Customer Satisfaction Program

N222369540 Fuel Economy Information Omitted On Monroney Label

Release Date: May 2022

6070595

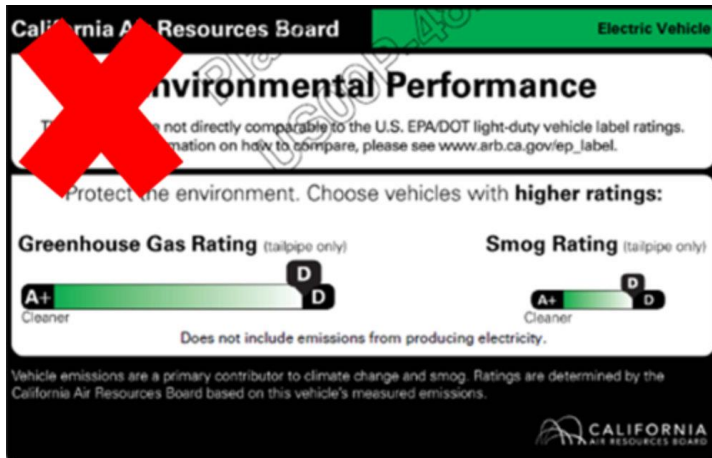
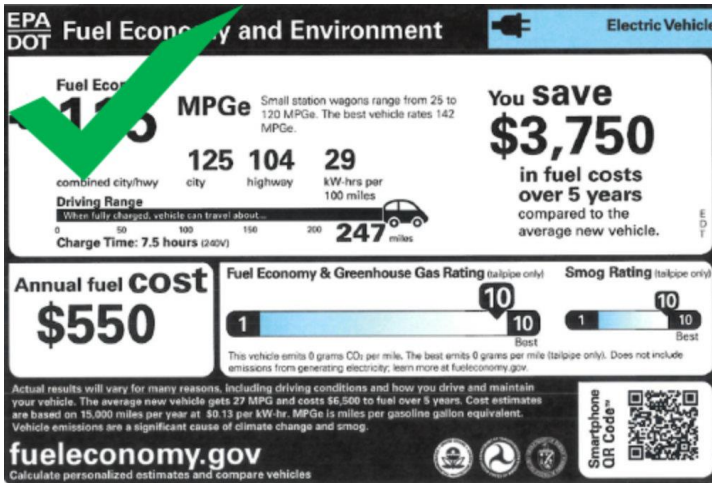
Condition	GM discovered an inadvertent error that omitted the fuel economy information on the window label (Monroney Label) of certain 2022 model year Chevrolet Bolt EUV vehicles. This label error has no effect on the safety and operation of the vehicles.
Correction	Dealers will inspect the Monroney label on vehicles in dealer inventory and replace if necessary prior to sale of the vehicle. GM will contact owners of the affected models to address this situation and provide a corrected fuel economy label overlay for the Monroney label that may be placed in the glovebox.

1. Inspect the fuel economy label on the Monroney label for incorrect information, see above images. The region will determine which label is shown.
 - If the Monroney label has the CORRECT information. No further action is required.
 - If the Monroney label has the INCORRECT information AND is in new vehicle inventory, continue to step 2.
 - If a customer owned vehicle or used VIN is "open" in IVH, continue to step 4.
2. Carefully remove the factory installed Monroney label from the vehicle's window. Discard this label.

3. Carefully affix the replacement Monroney label with corrected emissions section to the vehicle's window. No further action is required.
